Rezoning Transportation Analysis

Petition Number: 2026-019

General Location Identifier: 02907118

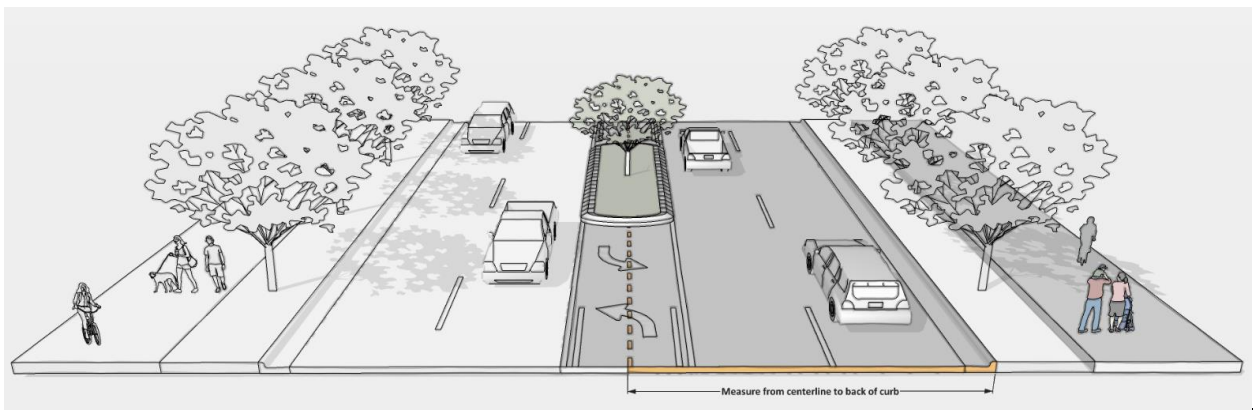
1. ~~Curbline:~~

- a. ~~Morehead Rd:~~ Location of future back of curb and gutter is to be shown at 30 feet from road centerline and must be shown in the future location according to UDO Article 32.7.

Clarifying Comment 5-21-26: Future back of curb location must be shown at 30 feet from road centerline throughout the entire parcel frontage of PID 02907118.

Note: NCDOT has determined that new curb and gutter will not be installed on Morehead Rd.

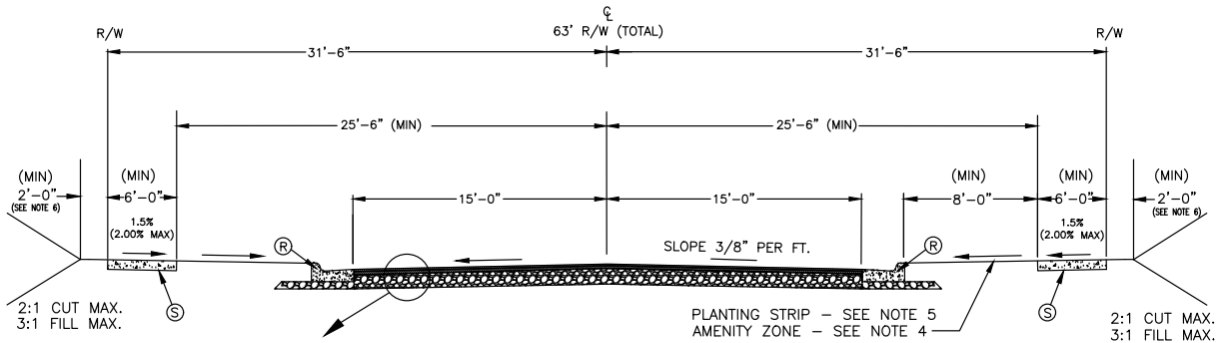
- b. ~~Old Holland Rd:~~ Location of future back of curb and gutter is to be shown at 17.5 feet from road centerline and must be shown in the future location according to UDO Article 32.7.

Label and dimension the back of curb and gutter from the centerline of each road on the site plan.
